I. TECHNICAL SPECIFICATION CHANGE REQUEST (TSCR) No. 156 (REV. 1)

TSCR 156 incorporates changes which are needed in order to comply with a condition of operation imposed by the Licensing Board as described in NRC's letter dated October 2, 1985 (Item 1.C). TSCR 156 (Rev. 1) incorporates NRC's comments from its review of TSCR 156.

Figure 5-3

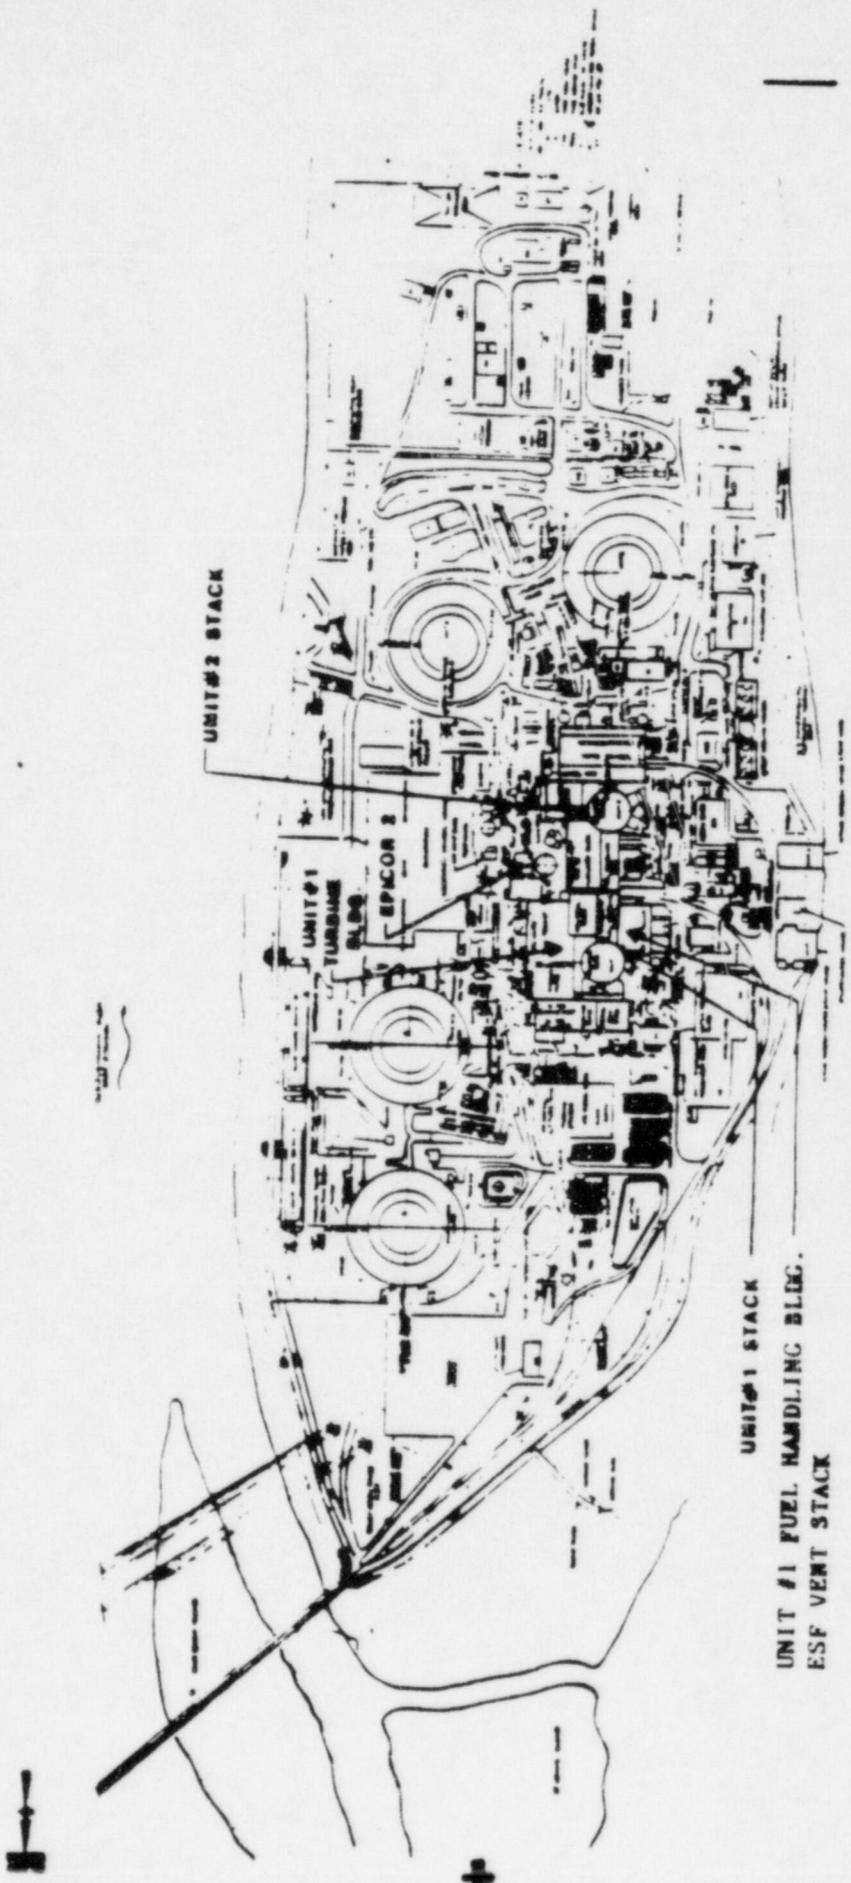
- 5) Figure 5.3 has been revised to add the new release point associated with the FHB ESF Vent Stack. The FHB ESF Air Treatment System effluent will be released at a new location in close proximity to the main stack. The effluent will be released at an elevation of 348' which is adequate since no credit has been taken in the analysis for elevated releases. The use of a separate release point for the FHB ESF Air Treatment System, where effluent monitoring is optimized for the flow conditions of the new system, enhances the ability to monitor effluents and assess dose rates. The FHB ESF Air Treatment System with its separate release point will not degrade the capabilities of the Auxiliary and FHB Air Treatment System and the environmental effects will be less.
